Re: Freeport-McMoRan Chino Mines Company- Updated Closure/Closeout Plan Continental Mine and Hanover Mountain Mines, Permit No. GR002RE, Response to Agencies' Comments and Request for Additional Information

Freeport-McMoRan Chino Mines Company (Chino) submitted an application to renew the Continental Mine Closure/Closeout Plan (CCP), Permit GR002RE on July 31, 2023. On November 6, 2023, Mining and Minerals Division (MMD) determined the application to be administratively complete. On November 20, 2023, an interagency inspection of Continental and Hanover Mountain Mines was conducted. In a letter dated February 19, 2024, Mining and Minerals Division (MMD) requested supplemental information and submitted a combined agency review comments and Request for Additional Information (RAI) from the following state agencies: New Mexico Mining and Minerals Division (MMD), the New Mexico Environment Department (NMED), the New Mexico Department of Game and Fish (NMDGF), and the New Mexico Department of Cultural Affairs - Historic Preservation Division (NMDCA/HPD), and the New Mexico State Forestry Division (NMSFD).

CLOSURE PLAN -
SWRDF - PROFILES

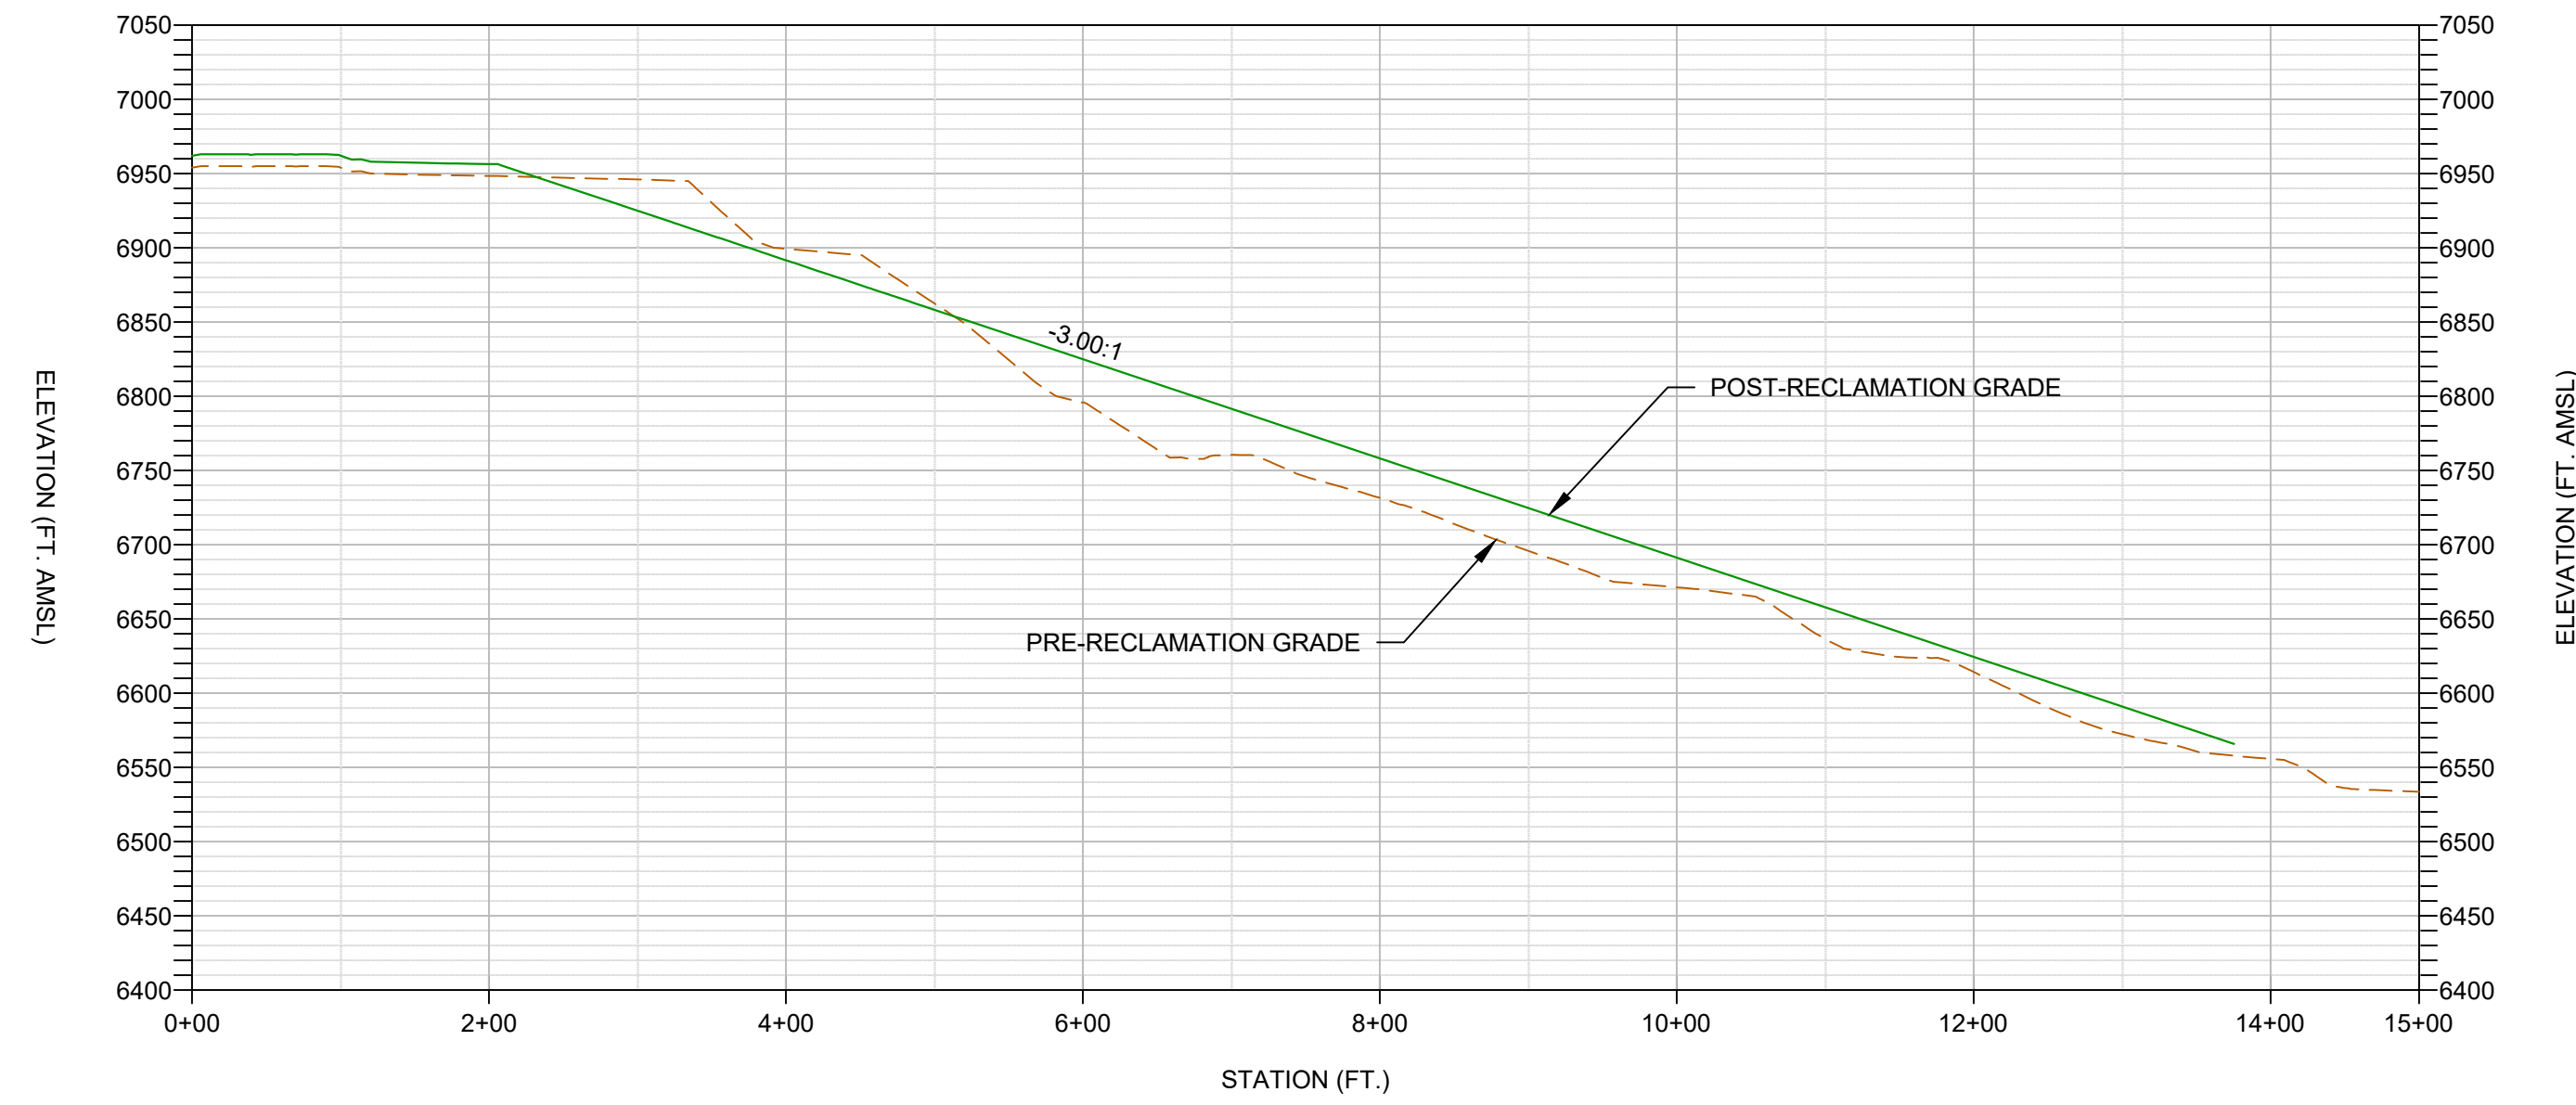
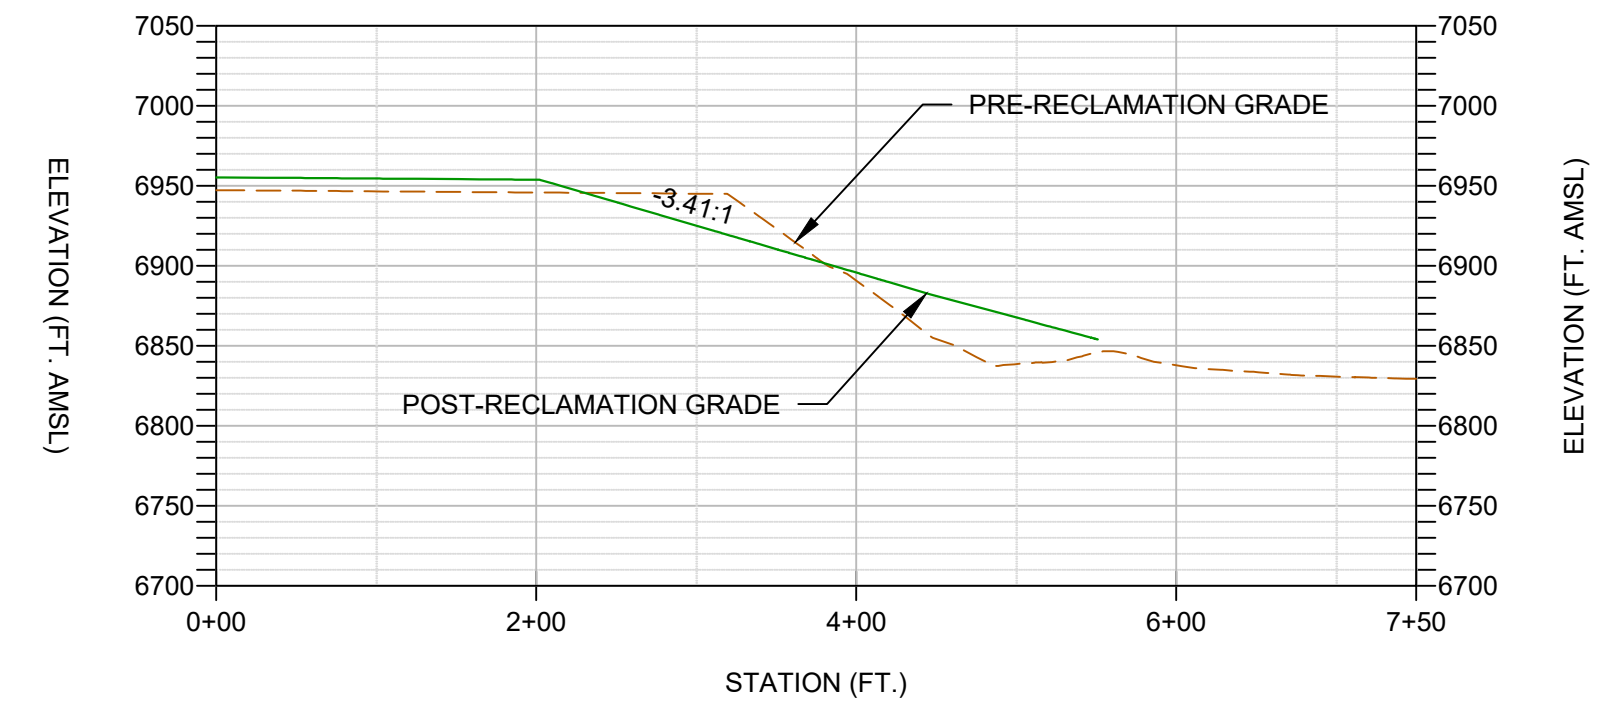
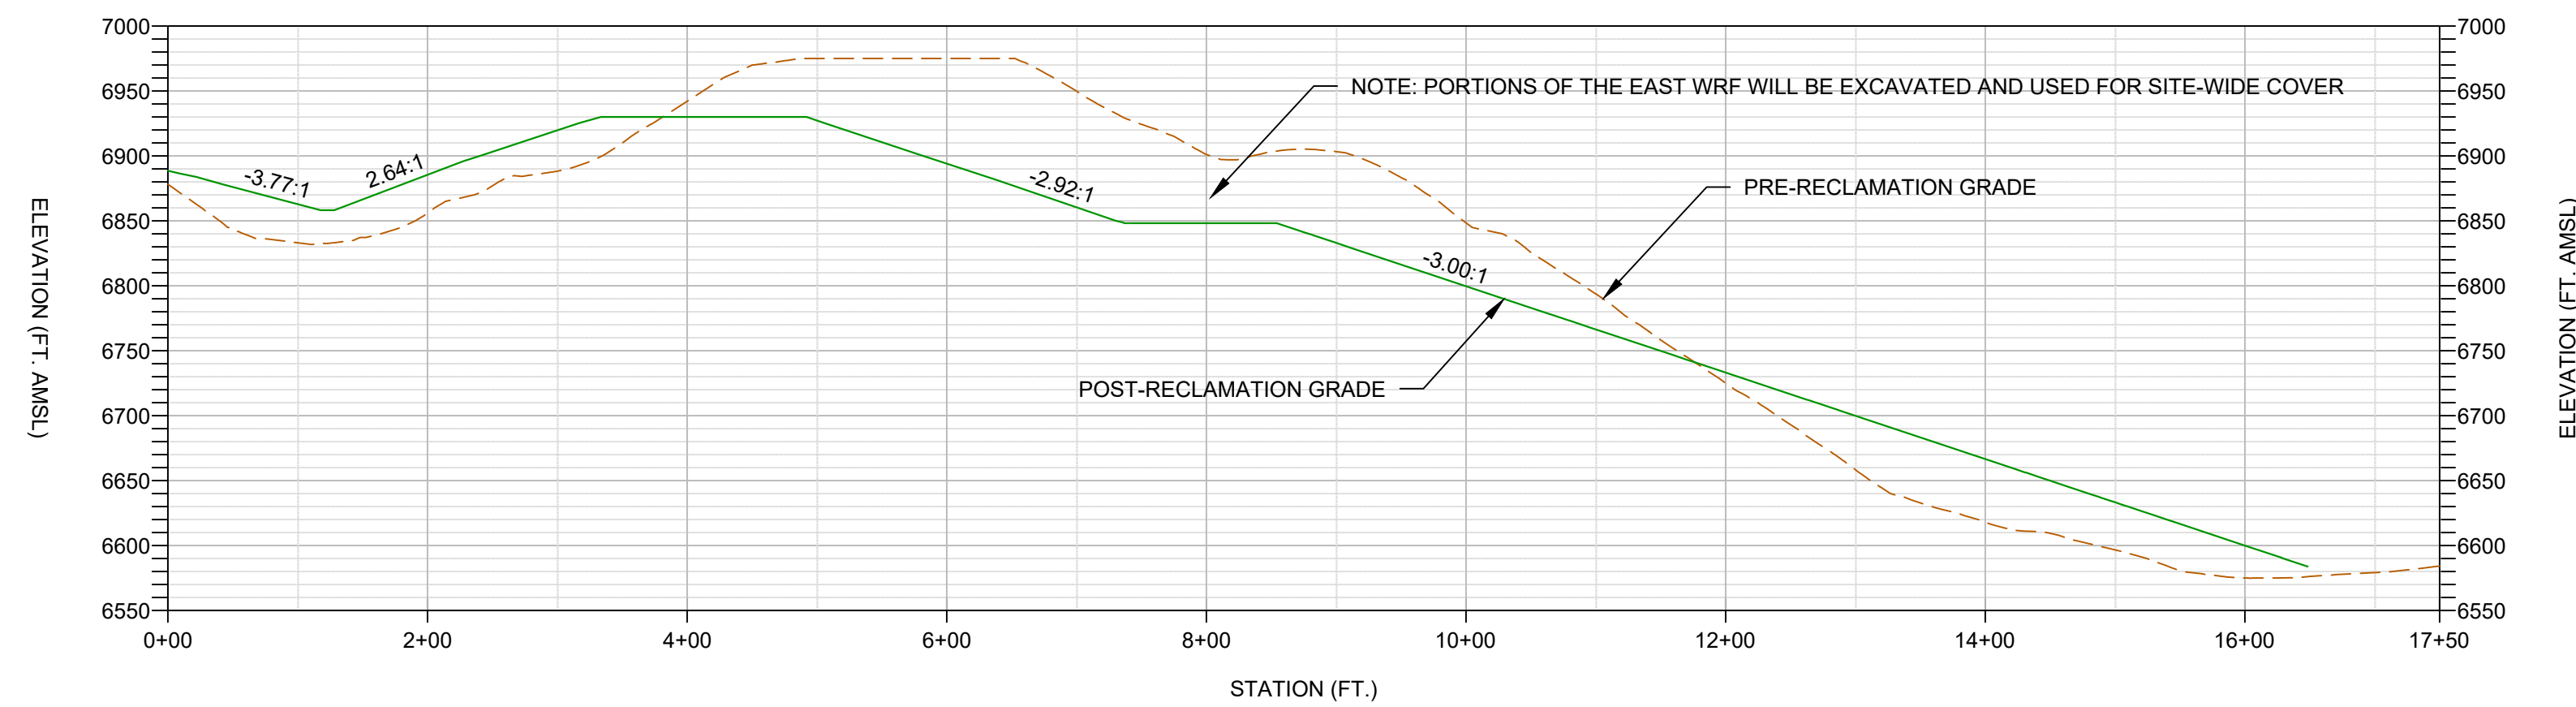
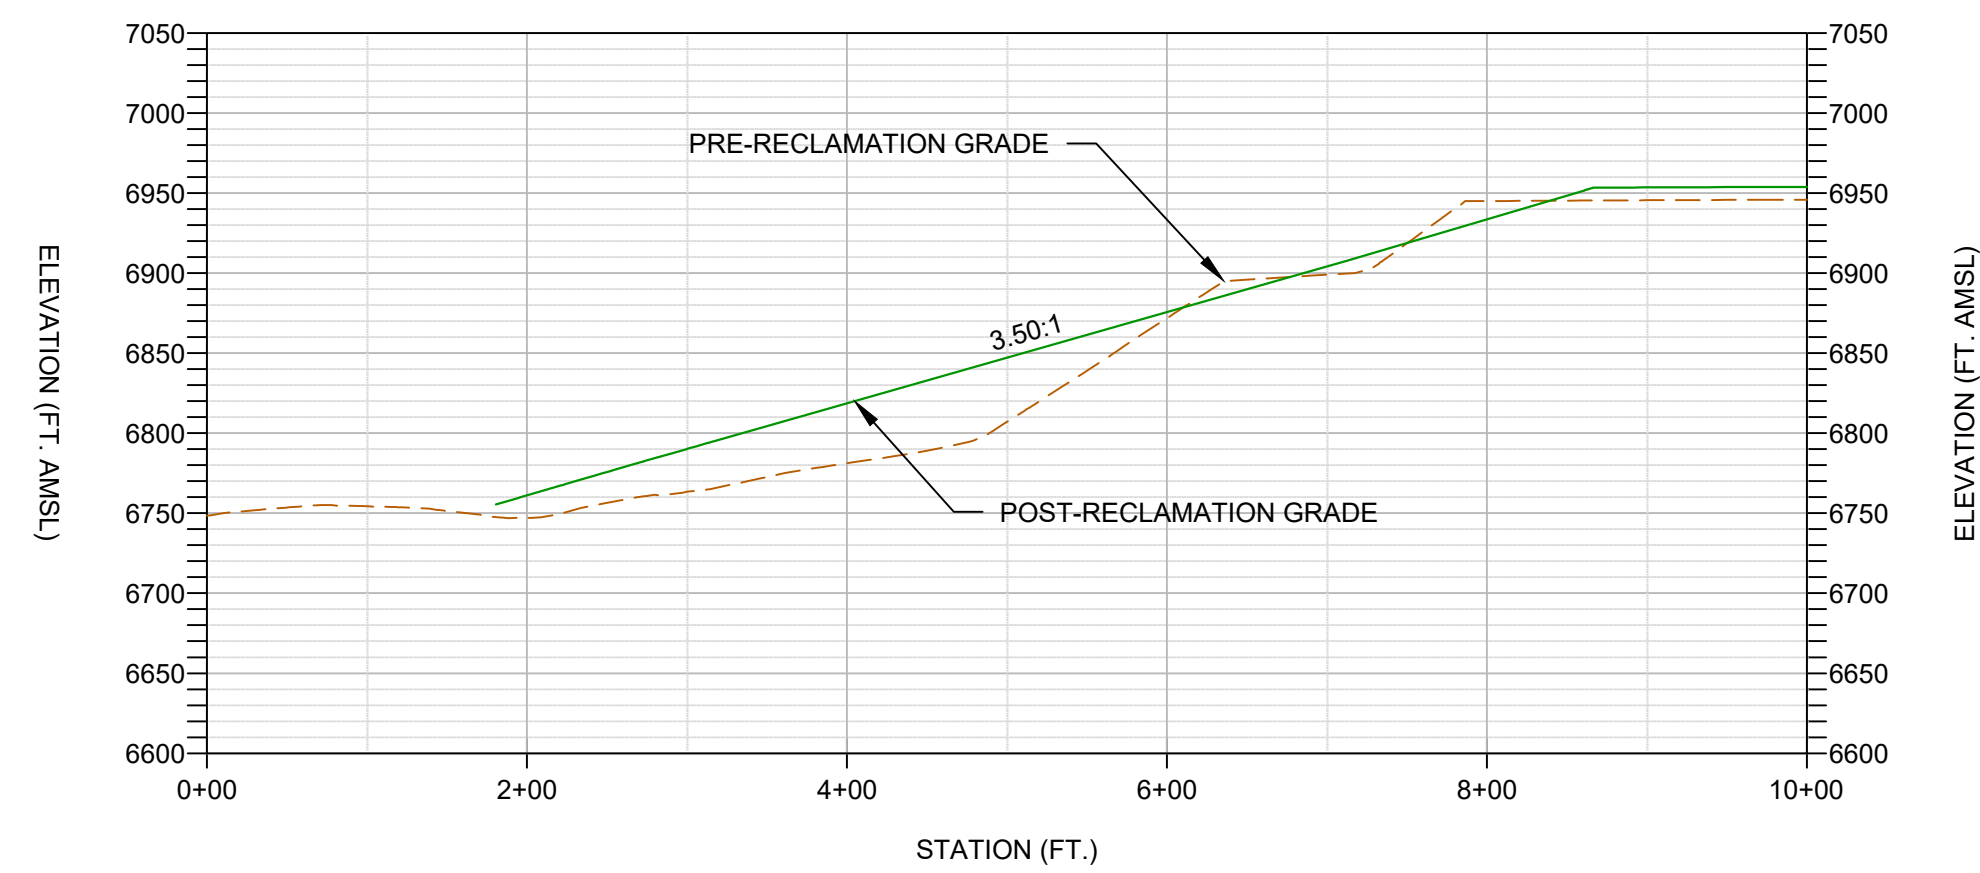
28. *Appendix E, Sheet 3 and Sheet 8. Pushdown of SWRDF crosses Fierro Road. Clarify if the pushdown will cover parts of Fierro Road, and if so, will the segment of the road be re-built.*

Chino appreciates this correction. Please see updated sheets 8 and 9.
